HOME2 SUITES FLOWOOD, MS 4th FLOOR PANELS

- ☒ REVIEWED
☐ REVIEWED AND NOTED
☐ REVISE AND RESUBMIT
☐ REJECTED
☐ RETURNED - SUBMITTAL NOT REQUIRED

Whisonant Engineering Services, LLC

DRAWING
Checked by *Bill Whisonant* Date 2/16/17

PNL.#: 4-06d QTY: 2

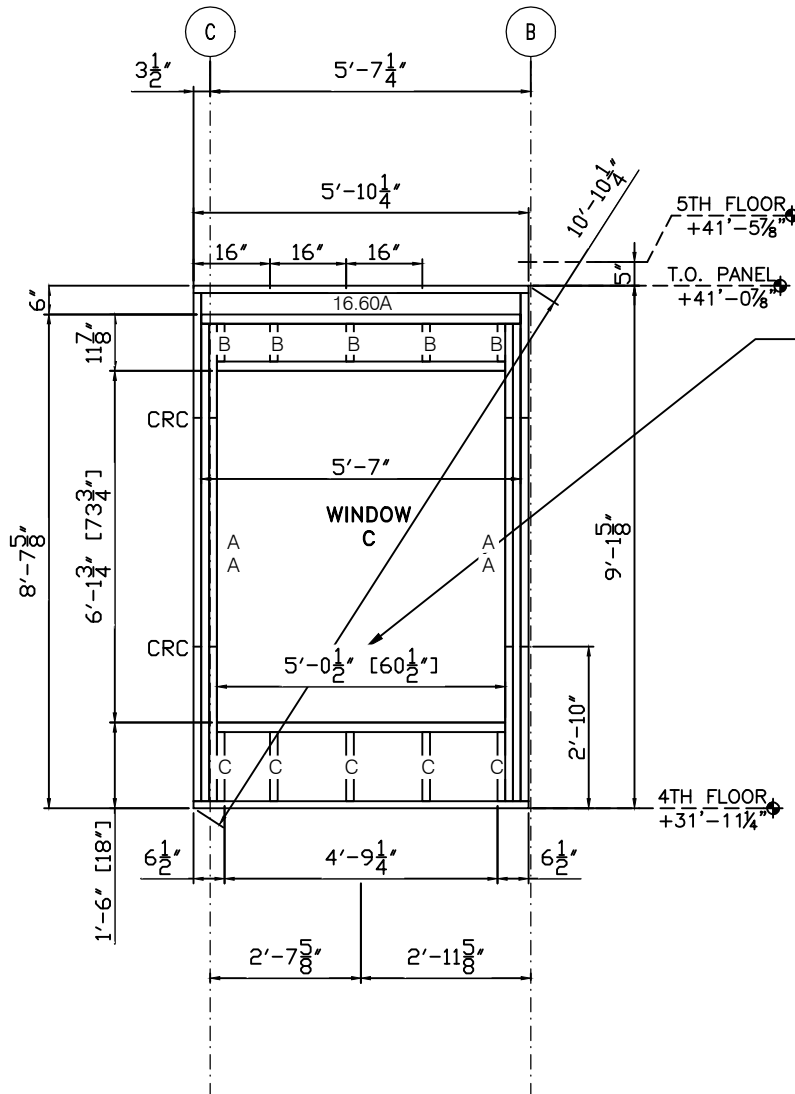
NOTE: BECAUSE OF REQUIRED SUPPORT STUDS, 60 1/2" CANNOT CENTER BETWEEN COLUMN LINES

PNL.#: 4-10d QTY: 3

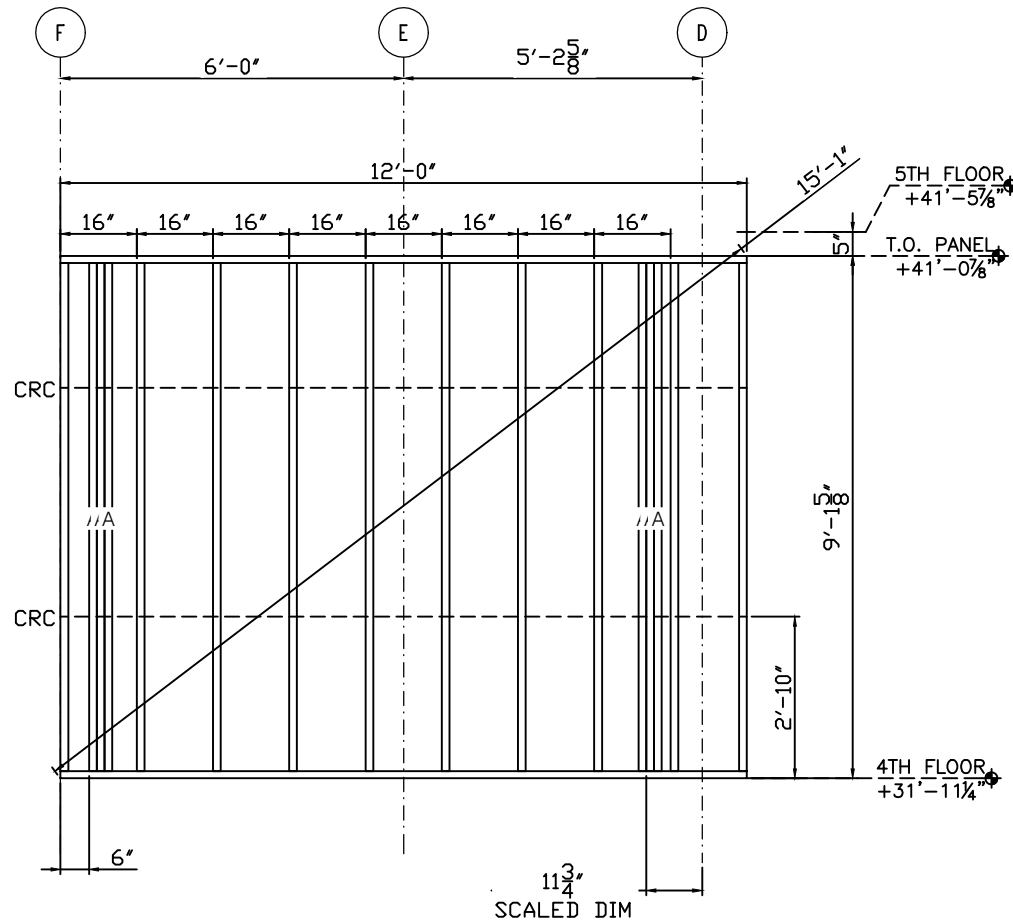
SCALED DIMENSION; SEE W104

PNL.#: 4-12d QTY: 1

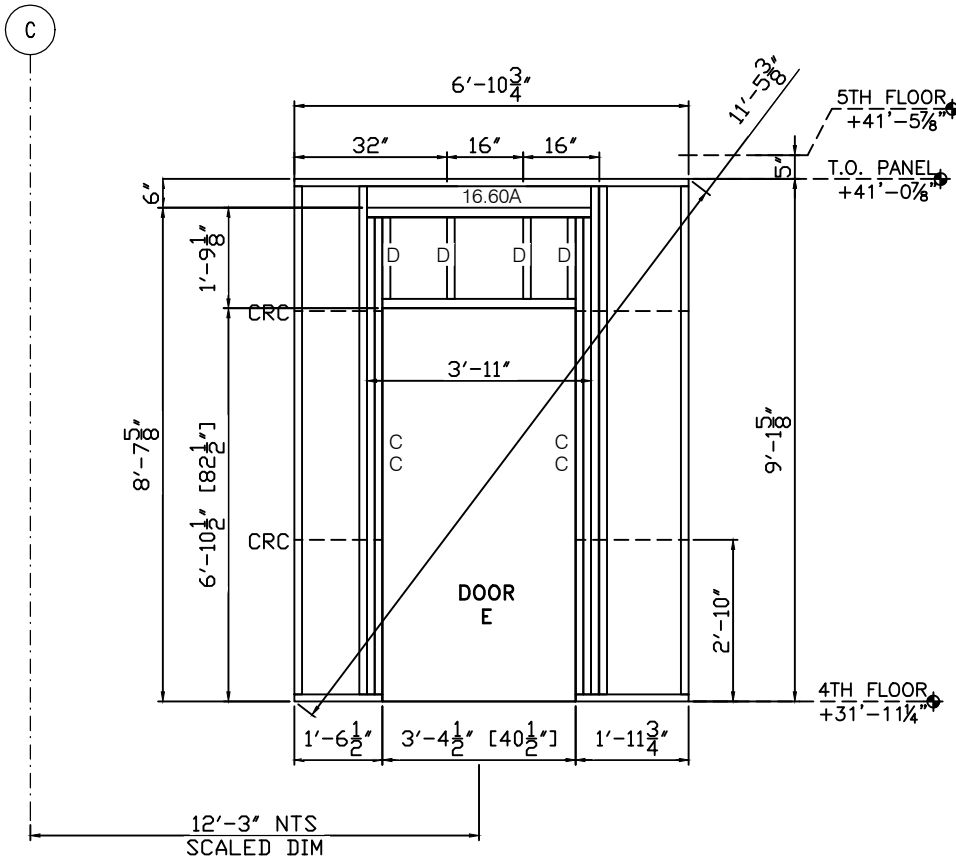
SCALED DIMENSION; SEE W104

PNL.#: 4-15d QTY: 1

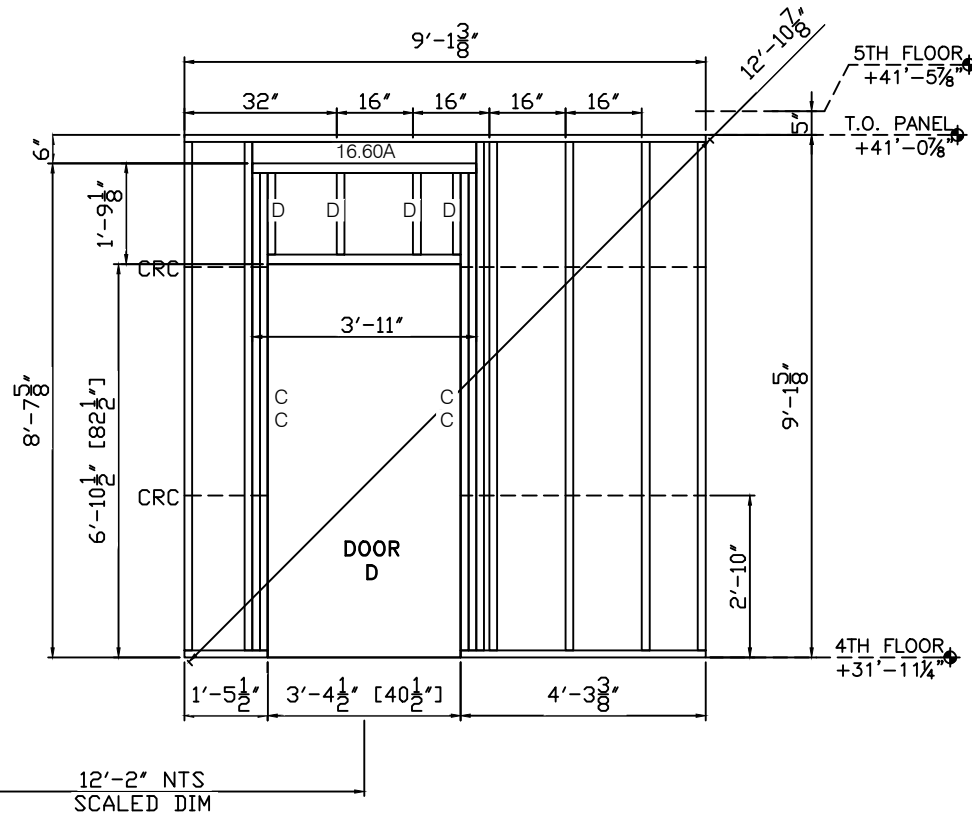
SCALED DIMENSION; SEE W104

PNL.#: 4-22c QTY: 1

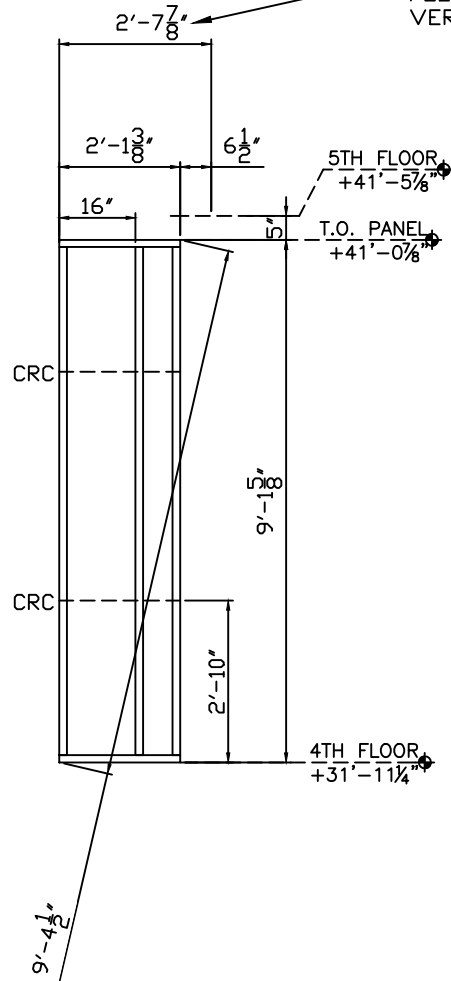
NOTE:
PLEASE
VERIFY

PNL.#: 4-27e QTY: 2

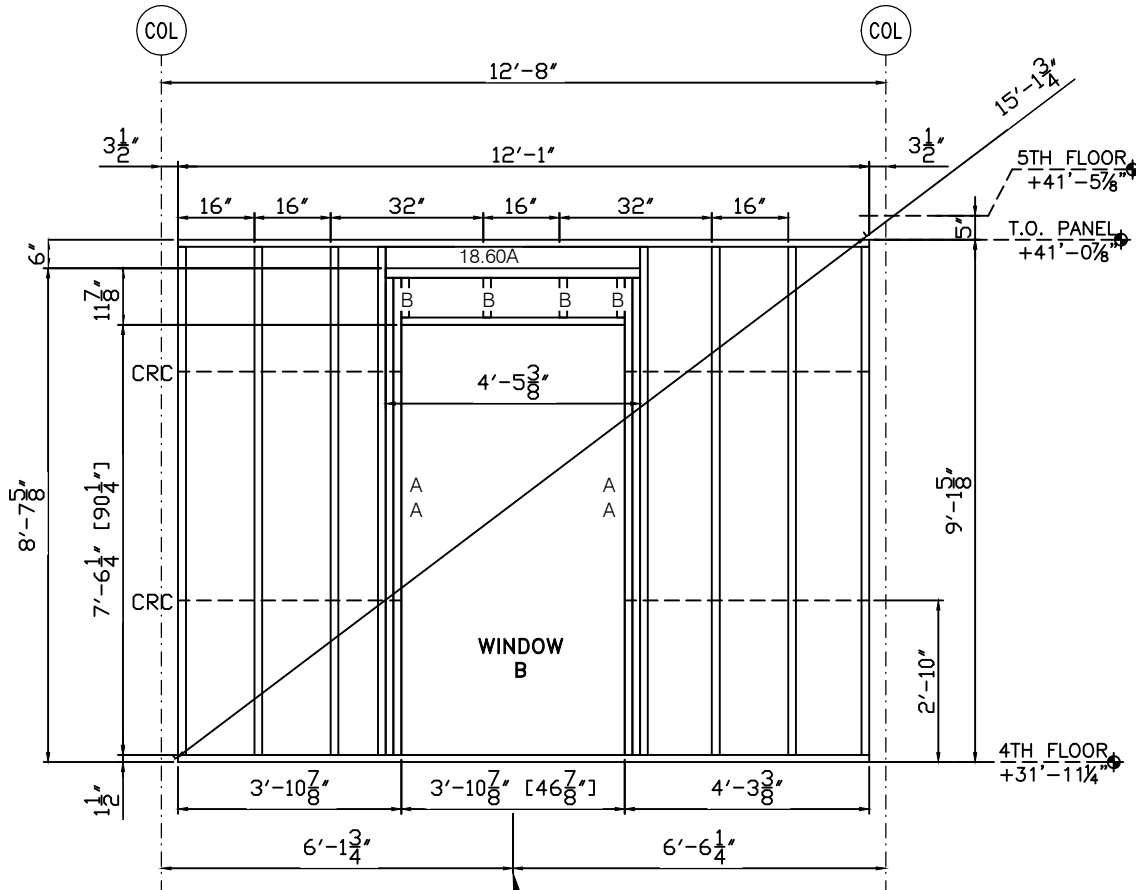
NOTE:
THIS WINDOW NOT CENTERED
TO ALIGN WITH WINDOW BELOW.
SEE 1-51e.

PNL.#: 4-28e QTY: 1

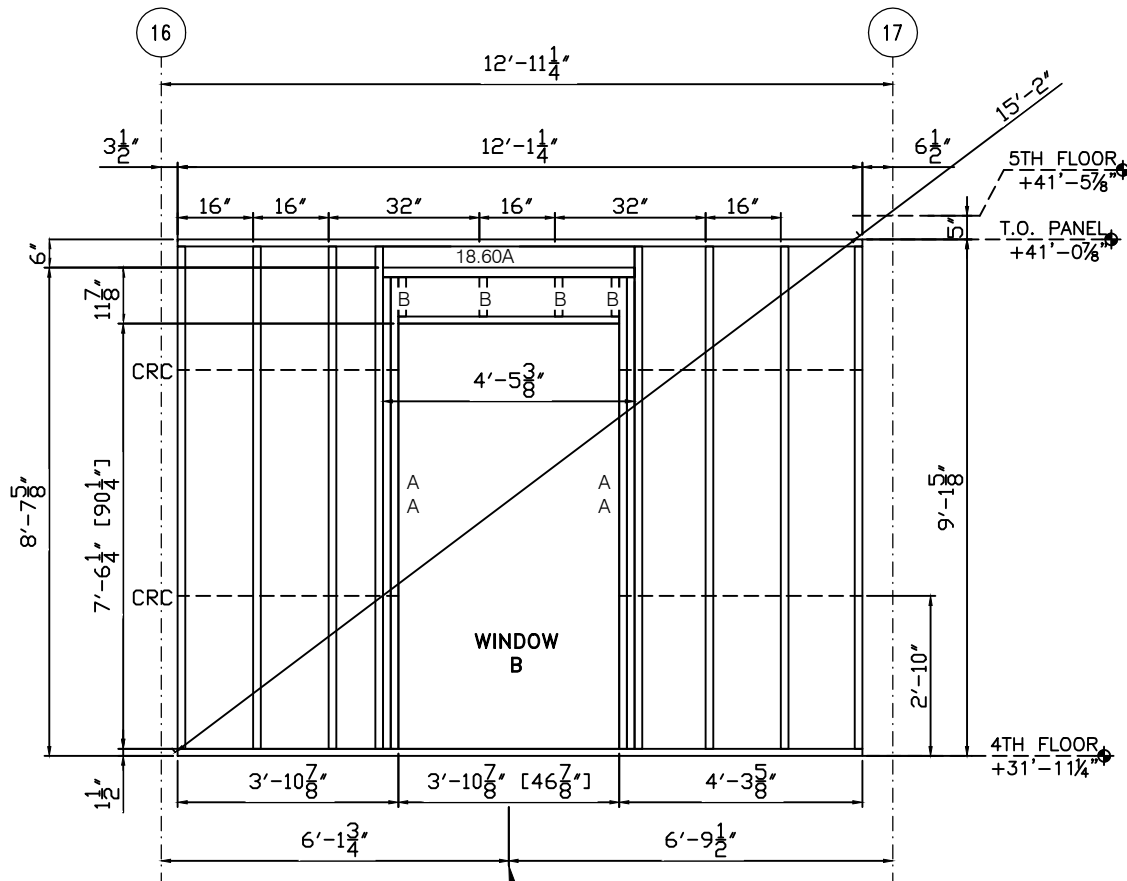
NOTE:
THIS WINDOW NOT CENTERED
TO ALIGN WITH WINDOW BELOW.
SEE 1-51e.

PNL.#: 4-46C QTY: 19

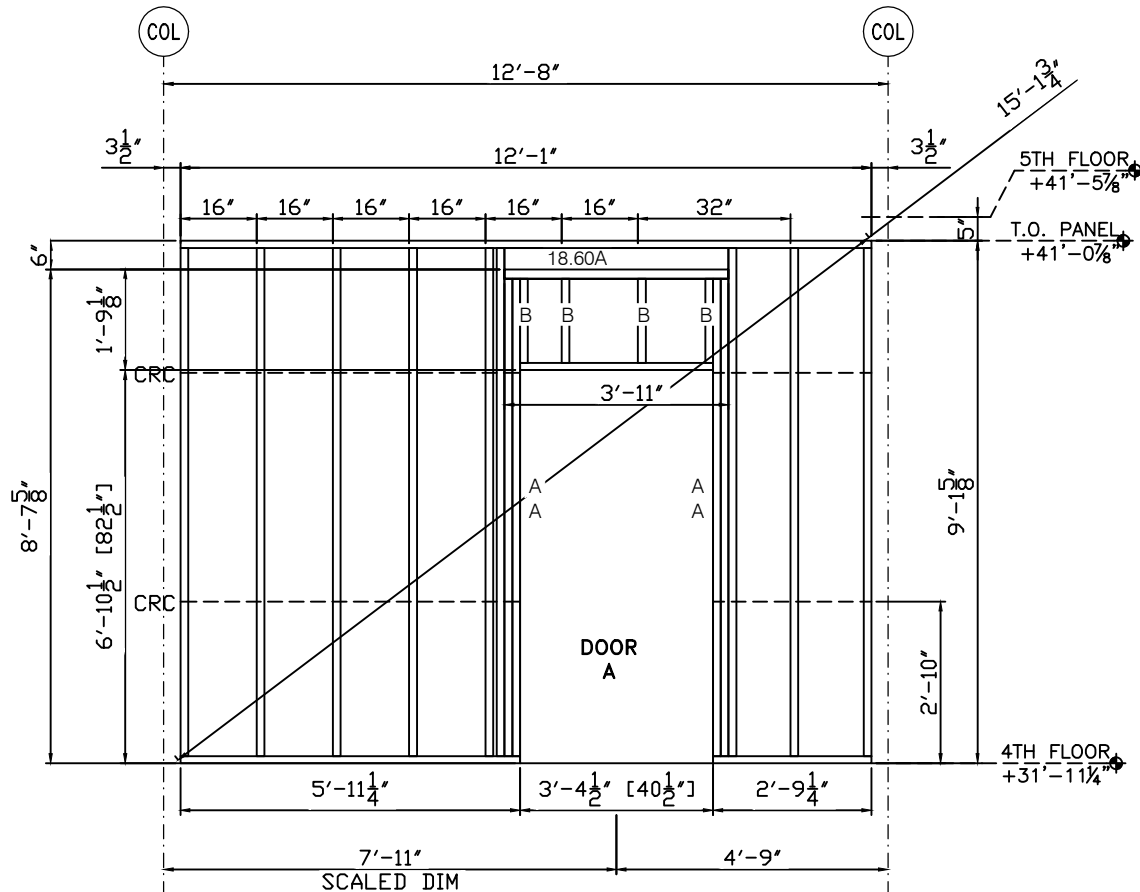
SCALED DIMENSION; SEE W104

PNL.#: 4-47C QTY: 2

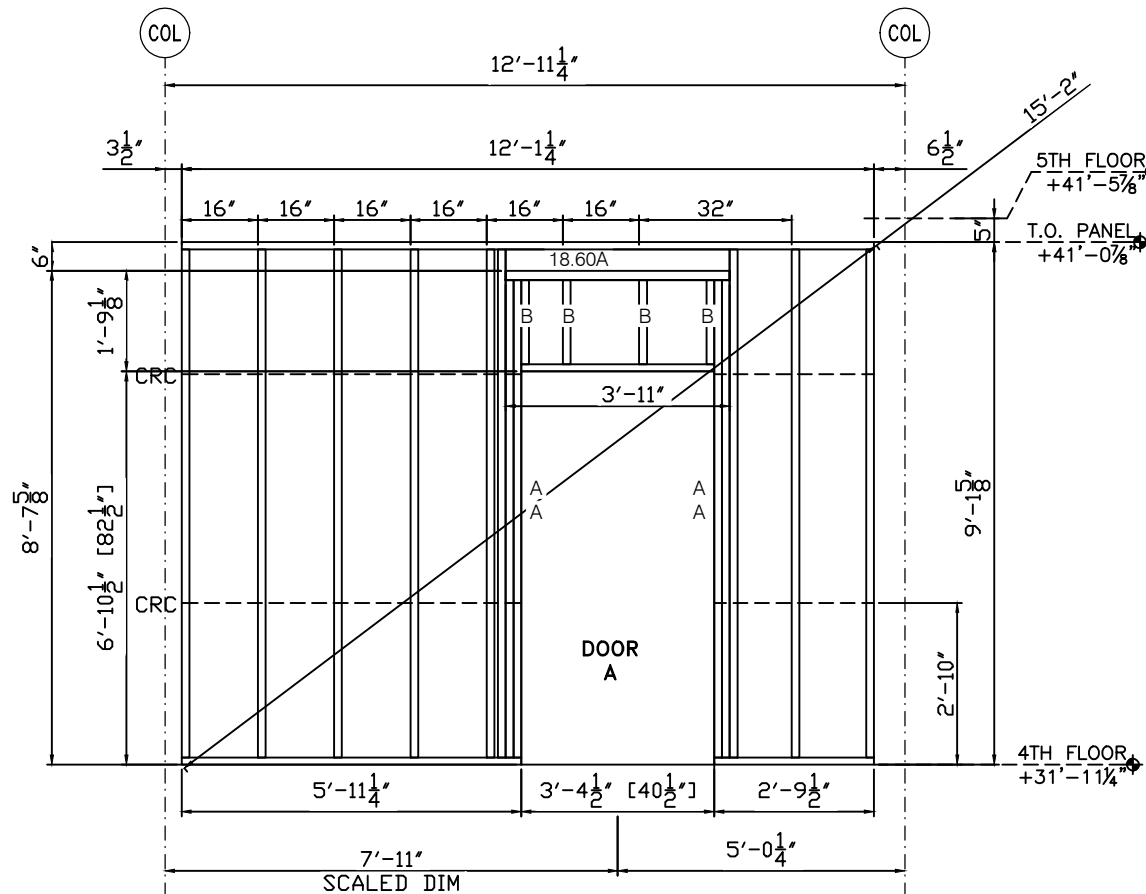
SCALED DIMENSION; SEE W104

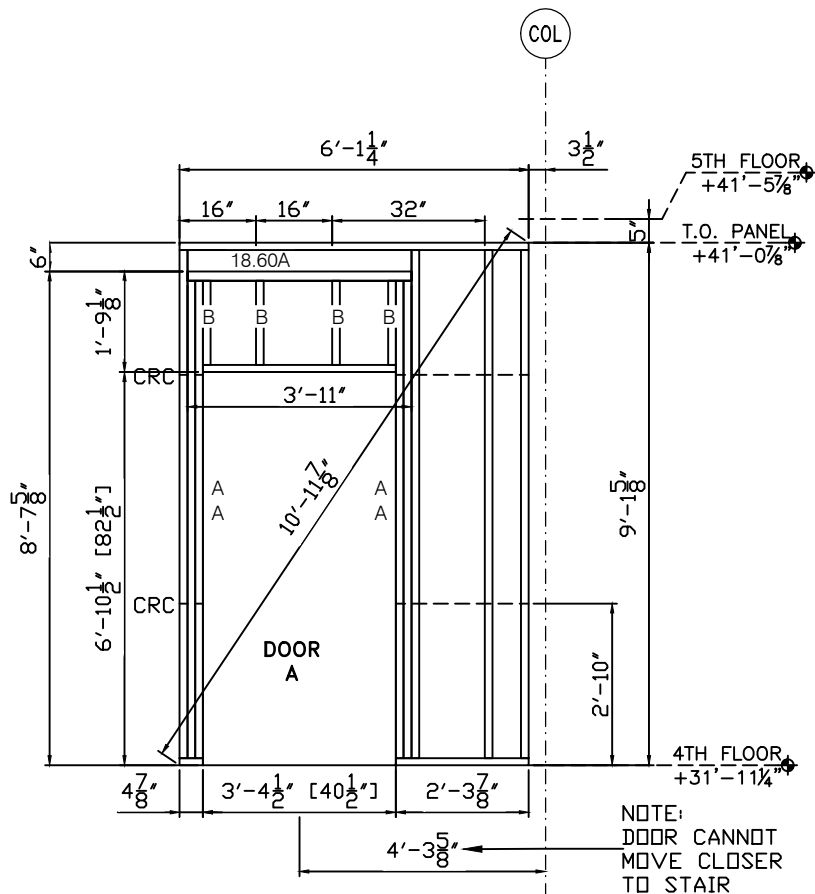
NOTE:
DOOR CANNOT
MOVE CLOSER
TO STAIR

PNL.#: 4-49C QTY: 1

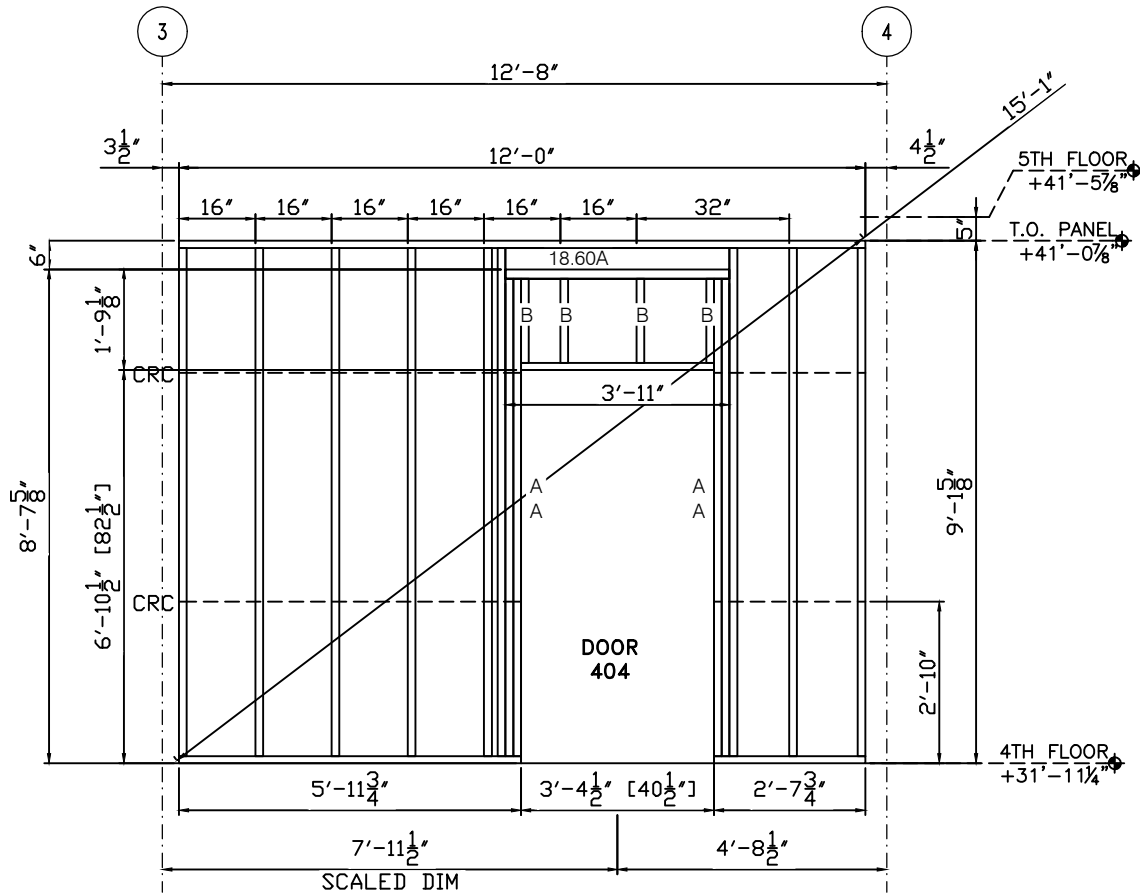
SCALED DIMENSION; SEE W104

PNL.#: 4-53c QTY: 1

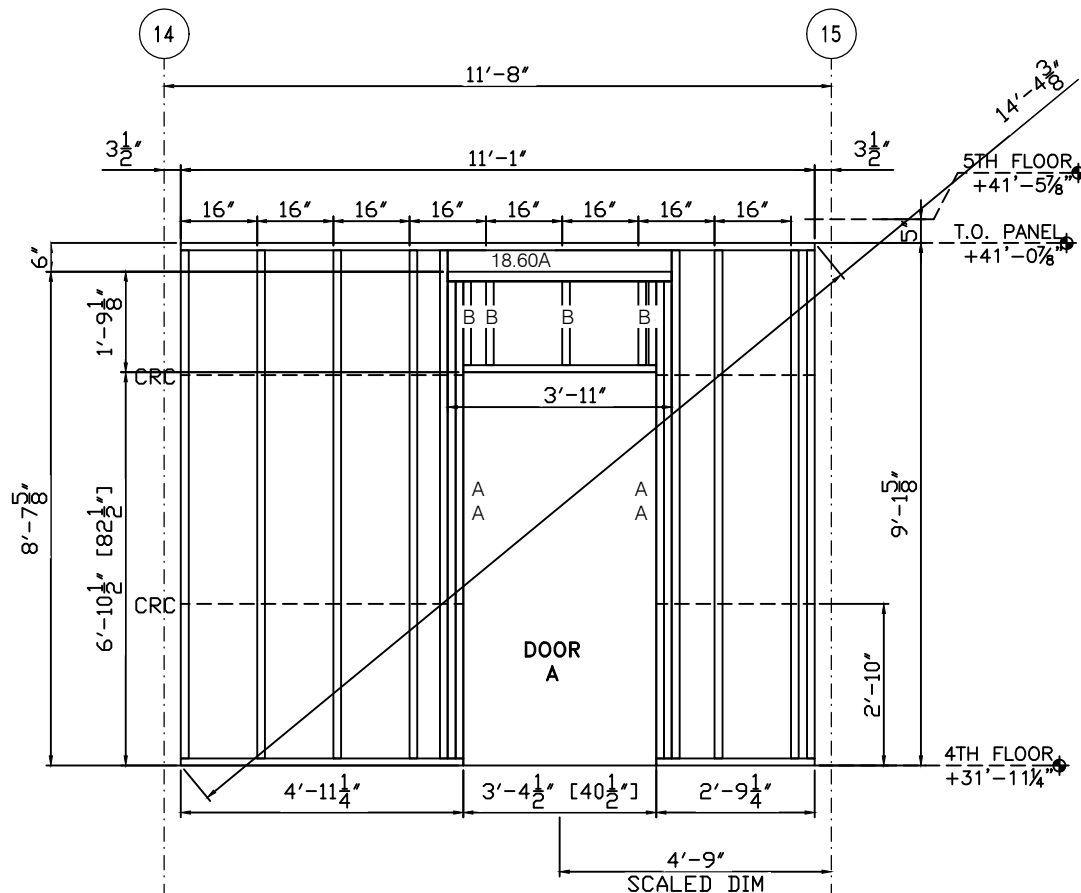
SCALED DIMENSION; SEE W104
